Safety Evaluation of the Early Site Permit Application in the Matter of PSEG Power, LLC and PSEG Nuclear, LLC for the PSEG Early Site Permit Site

U. S. Nuclear Regulatory Commission
Office of New Reactors
Washington, DC 20555-0001

September 2015

Figure 2.4.14-1 Proposed PSEG Site Layout (based on SSAR Revision 3, Figure 1.2-3)

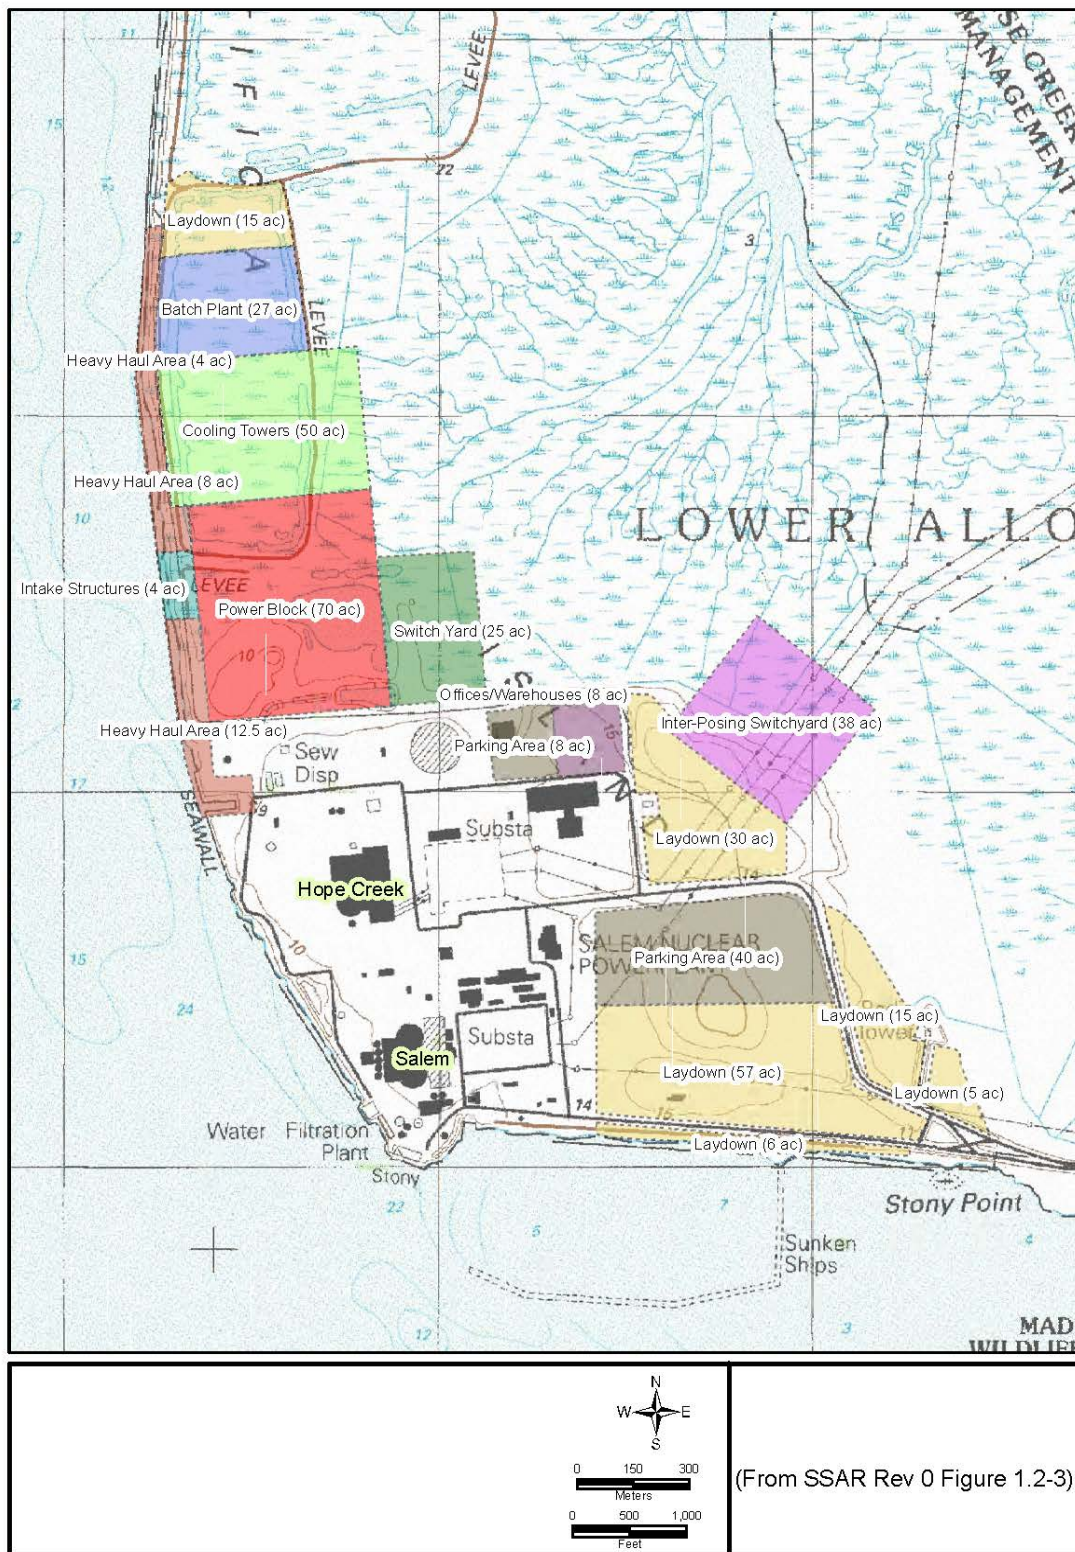
Coordinates for the power block reference point are provided in geodetic and UTM systems. SSAR Section 2.1.1.2 (Paragraph 2) and SSAR Figure 1.2–3 identified the UTM coordinates without units, which appear to be measured in feet. Therefore, in RAI 9, Question 02.01.01-1, the staff requested that the applicant annotate the list of UTM coordinates in the SSAR and to do so in the marginal notes on SSAR Figure 1.2-3 with the correct units of measure. In a March 21, 2011, response to RAI 9, Question 02.01.01-1, the applicant provided a revision to

The PSEG proposed Exclusion Area Boundary (EAB) is a circle at least 600 m (1968 ft) from the edge of the power block area in all directions as shown in SSAR Figure 1.2-3. As shown in SSAR Figure 2.1-23, the proposed EAB extends beyond the PSEG Site property line to west (into the Delaware River) and to the north and northeast. The total area that the EAB encompasses is 3.0 km² (743 acres), of which 0.91 km² (224 acres) is in the Delaware River and 1.17 km² (288 acres) is in land that PSEG currently owns. PSEG will own an additional 0.344 km² (85 acres) of land when it completes property acquisition with the USACE. The land within the EAB that PSEG does not own consists of 0.59 km² (146 acres), which the Federal Government owns. No public roads, railroads, or structures other than the existing PSEG power plant facilities are located within any part of the EAB. From the information in SSAR Section 2.1.1.2 and SSAR Figure 1.2-3, it appears to the staff that the additional 0.344 km² (85 acres) of land is bounded by the area, as described in "PSEG Proposed New Property Line." In RAI 9, Question 02.01.01-2, the staff requested that the applicant distinguish the different areas in EAB and clarify them in SSAR Section 2.1.1.2 and SSAR Figure 1.2-3 accordingly. In a March 21, 2011, response to RAI 9, Question 02.01.01-2, the applicant provided clarification along with proposed revisions to SSAR Section 2.1.1.2 and SSAR Figure 1.2-3. The staff reviewed the response and found the applicant's clarification appropriate and adequate, and therefore acceptable. The staff also confirmed the inclusion of the proposed revisions in SSAR Section 2.1.1.2 and SSAR Figure 1.2-3, Revision 1, submitted on May 21, 2012. Accordingly, the staff considers RAI 9, Question 02.01.01-2, resolved.

The staff reviewed the site area map in the SSAR (Figure 1.2-3) for the proposed PSEG Site to verify that the distance from the proposed power block to the boundary line of the exclusion area meets the guidance in NUREG-0800, Section 2.1.1. Based on its review of the information in the SSAR, and confirmatory review of prominent, natural, and manmade features of the area as found in publicly available documentation, the staff finds the information provided by the applicant with regard to the PSEG Site location and description adequate and acceptable.

SSAR text in Section 2.1.1.2 and SSAR Figure 1.2-3 with the English unit of measurement (in feet), and committed to revise the SSAR with this information. The staff reviewed the applicant's response and subsequently confirmed that SSAR Revision 1, submitted on May 21, 2012, contained the information as committed in the RAI response. Accordingly, the staff finds the applicant's response acceptable and considers RAI 9, Question 02.01.01-1, resolved.
